IFB # 2020-026
Roof Removal & Replacement at the Bent Mountain Center

ADDENDUM NO. 1

Revised Plans and Specifications

IFB# 2020-026
Roof Removal & Replacement at the Bent Mountain Center
ADDENDUM NO. 1

ROOF DEMOLITION PLAN

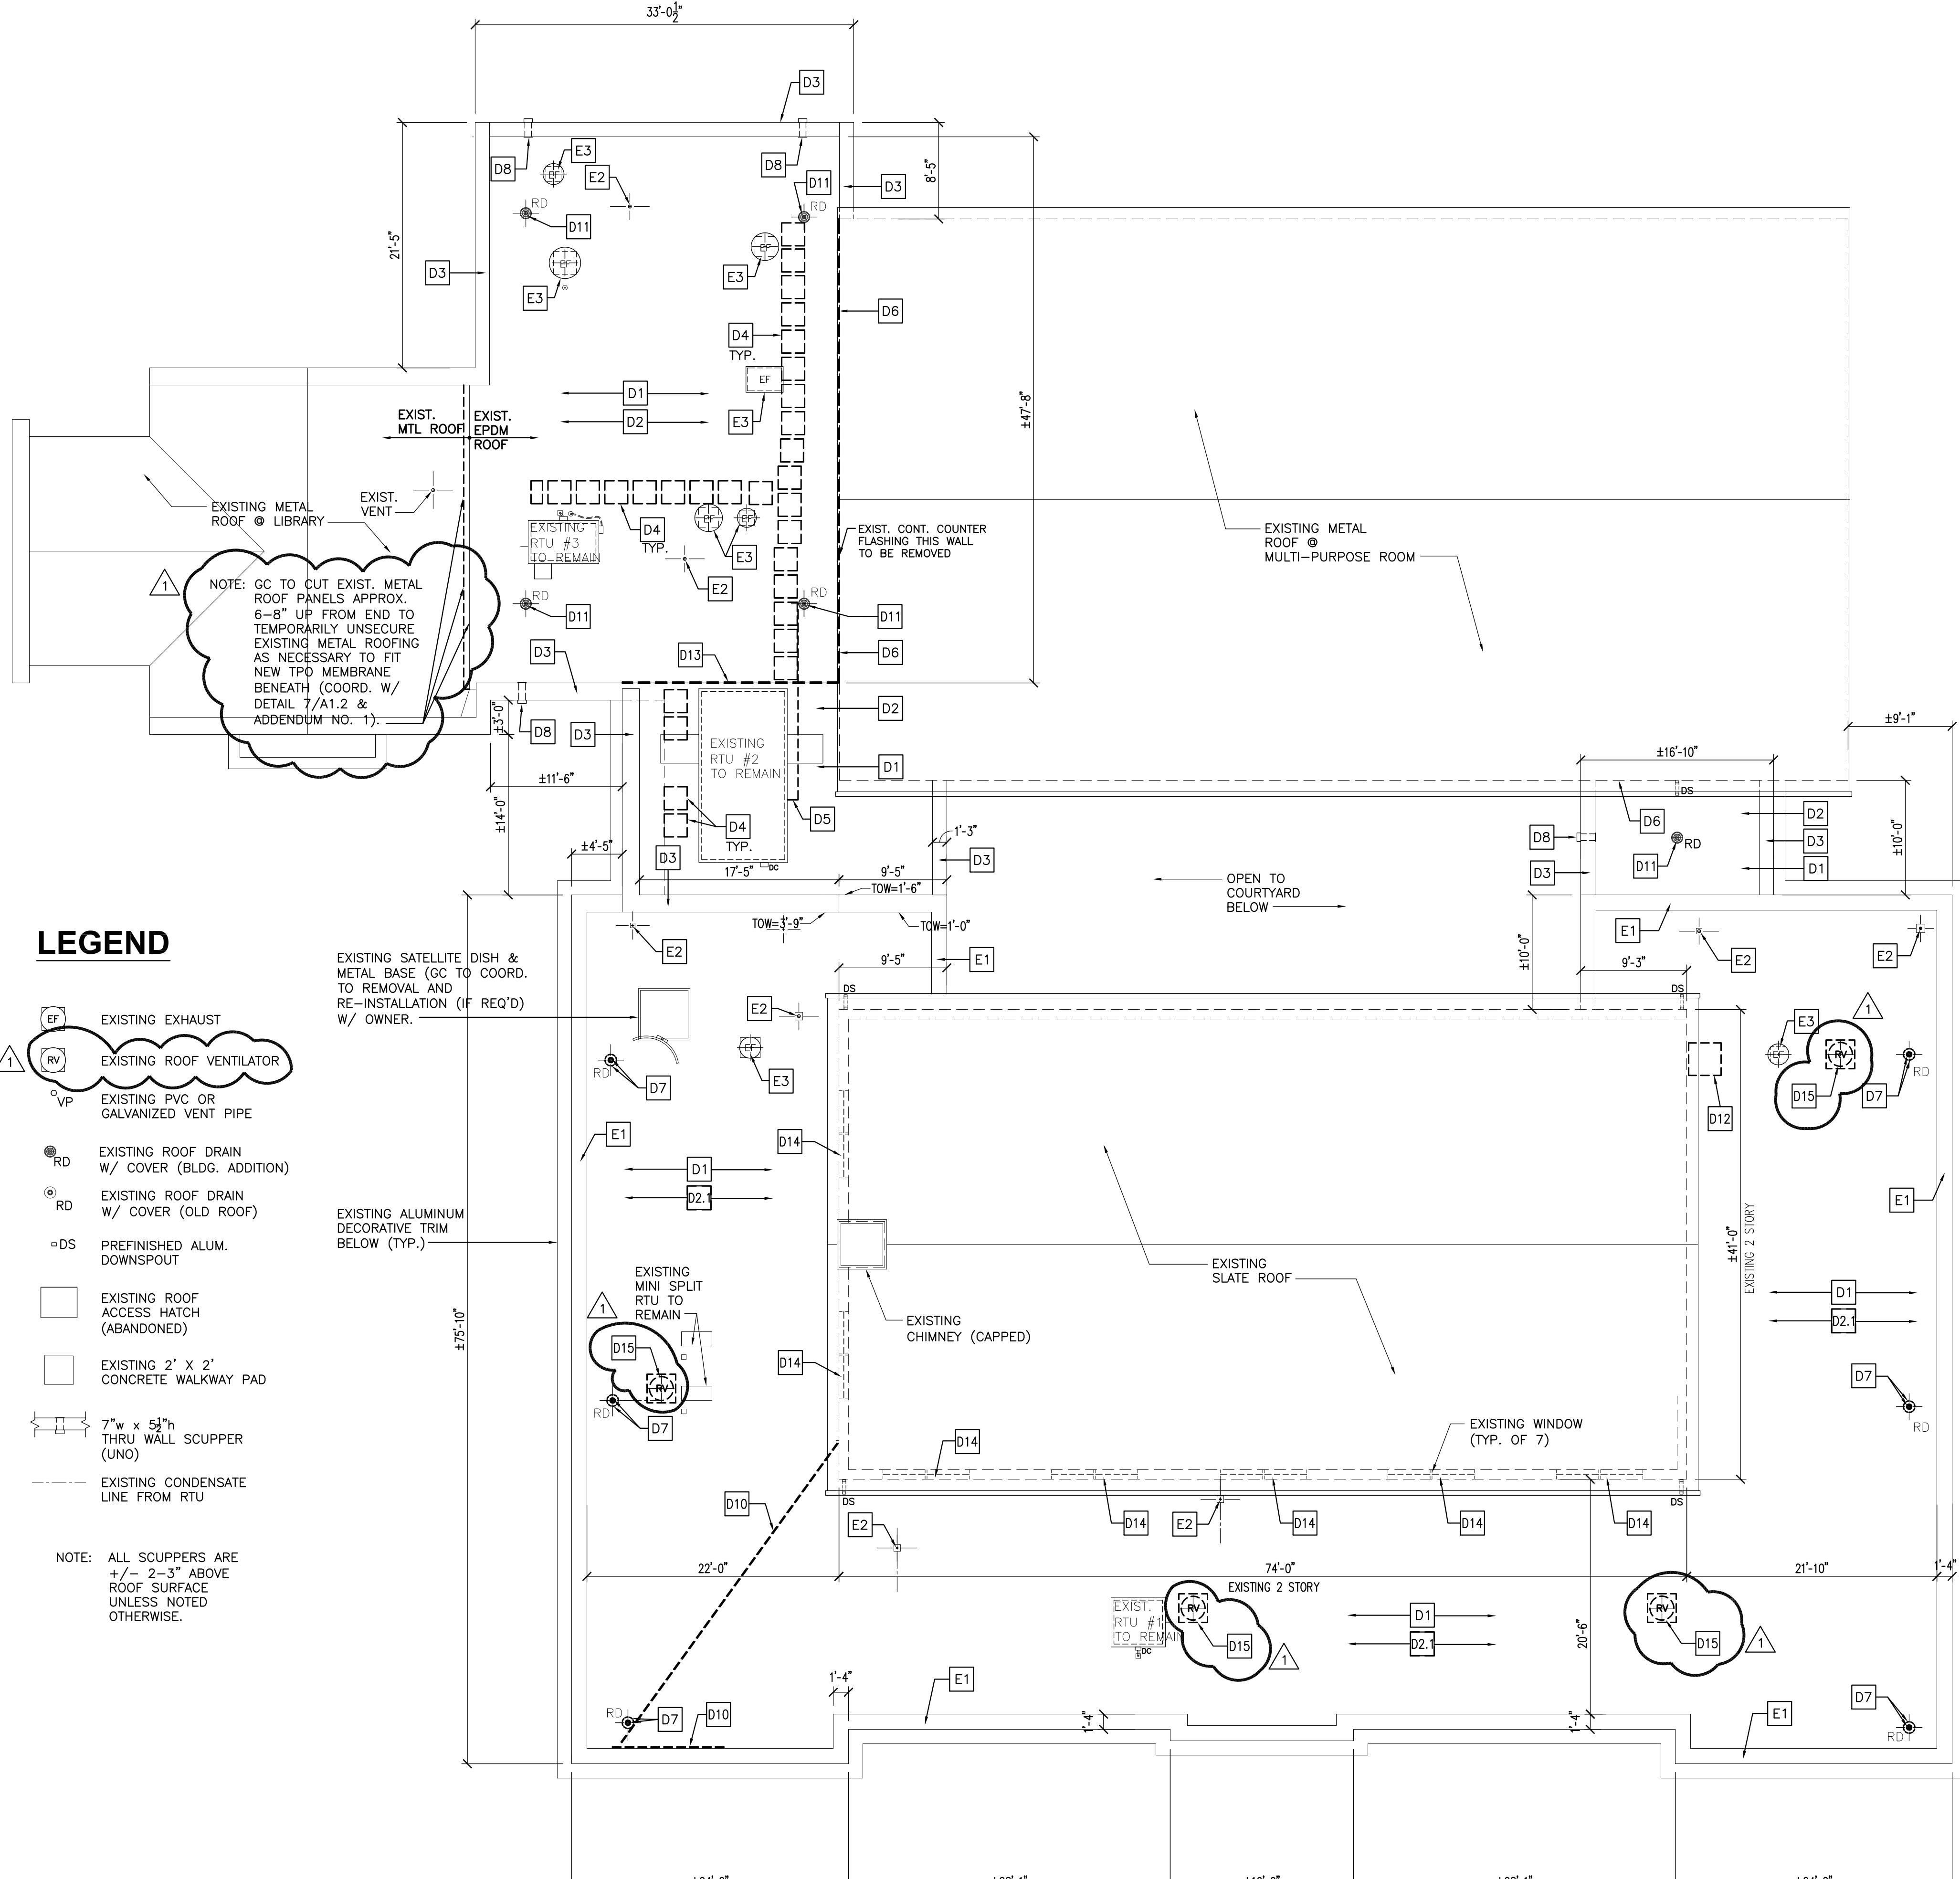
- a.** Revision to sheet D1.1: Attic ventilators shall be removed and replaced; cost to be included in the Base Bid line item of the Price Form. Replacement ventilator shall be Greenheck GRSI Gravity Ventilator or equivalent, with prefab curb. Please see Exhibit B to Addendum 1 for item specifications; the estimated appropriate model size 20 is highlighted. Size may differ slightly once roof is removed and opening size is verified by Contractor. Complete specifications of any equivalent model proposed must be included in the bid package as applicable. (Coordinate new roof ventilator with sheet A1.1).

- b.** Use 5.20" minimum, R-30 polyiso rigid insulation; $\frac{1}{4}$ "/ft. slope as per specs (Sheet A1.1).
 - c.** Cut back existing metal roof approximately 6-8" and remove existing cleats for installation of new metal flashing (Sheet D1.1 & Detail 7/A1.2).

- D13 REMOVE EXISTING GRAVEL STOP.
- D14 REMOVE EXISTING GALVANIZED WINDOW SILL FLASHING AND EXISTING STORM WINDOW (SEE DETAIL 9/A1.2).
- D15 REMOVE EXISTING ROOF VENTILATOR.

ROOF PLAN

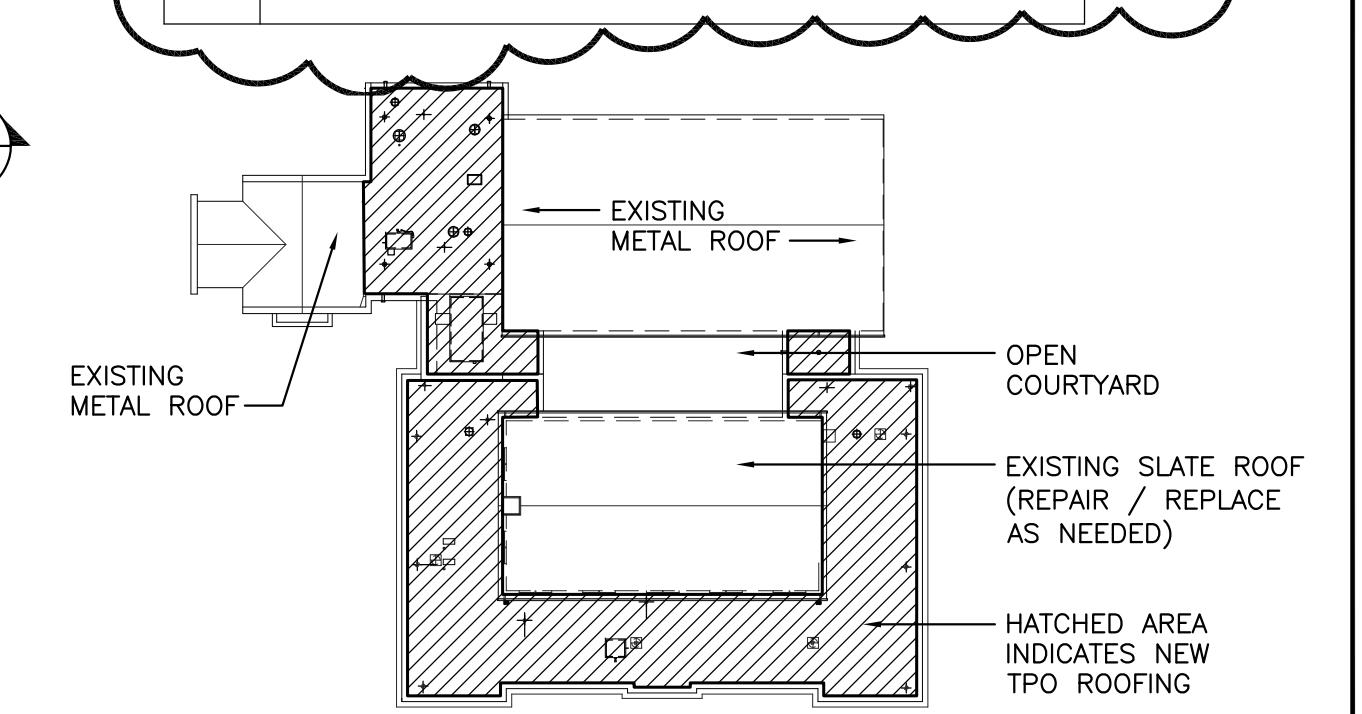
- d.** Roof slopes to be revised to show crickets at both sides and front (sheet A1.1).
 - e.** Use 5/16" cementitious panel at existing window openings; Detail 9/A1.2 to be revised.

10. INSTALL NEW CONT. P.T. 2 X NAILER (AT WINDOW SILL AND HEAD), 3/4" P.T. PLYWD AND 5/16" CEMENTITIOUS PANEL AT ENTIRE EXISTING WINDOW OPENING. SEE DETAIL 9/A1.2.

13. NEW ROOF VENTILATOR - SEE ADDENDUM NO. 1.
